Deviation From Design

DfD :	DfD-0028	Follow Up Required	Taran Laval – SAAA Builder 7417 Van's Aircraft RV7 – 73918 VH-TJL
		N

AILERON GAP FAIRING INBOARD RIVET

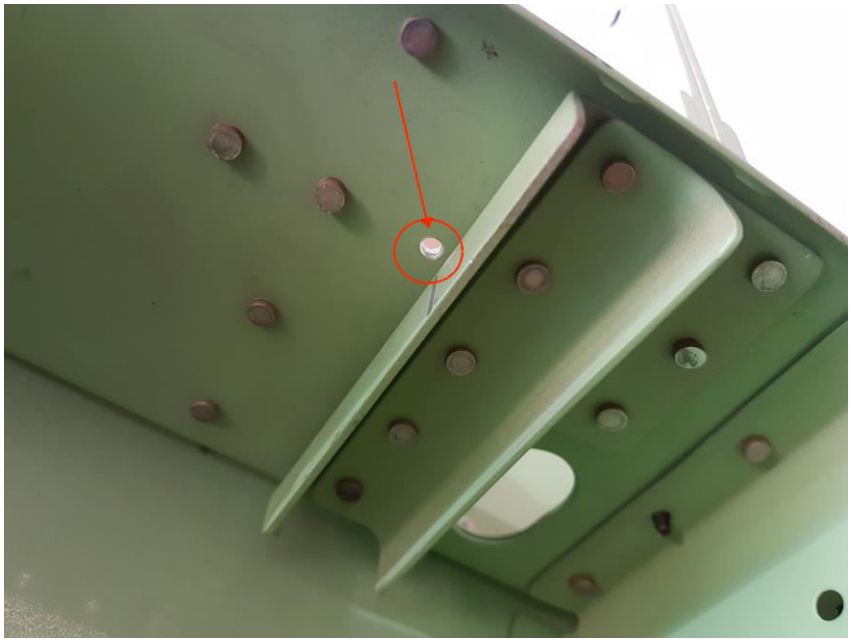
DURING CONSTRUCTION OF MY FIRST WING VANS AIRCRAFT ISSUED A SERVICE BULLETIN (SB16-03-28), THIS SB INVOLVED RIVETEING DOUBLERS BEHIND THE AILERON BRACKET TO AVOID FUTURE CRACKING, SO I COMPLIED WITH THAT DURING CONSTRUCTION.

WHEN IT CAME TIME TO RIVET THE AILERON GAP FAIRING TO THE REAR SPAR I FOUND THAT THE INBOARD MOST RIVET COULD NOT BE SET DUE TO INTERFERENCE WITH THE NEWLY INSTALLED DOUBLERS.

I REQUESTED FROM VANS TO INSTALL A BLIND RIVET IN THAT POSITION

VANS AUTHORISED THE USE OF A MSP-42 PULLED RIVET IN THIS LOCATION
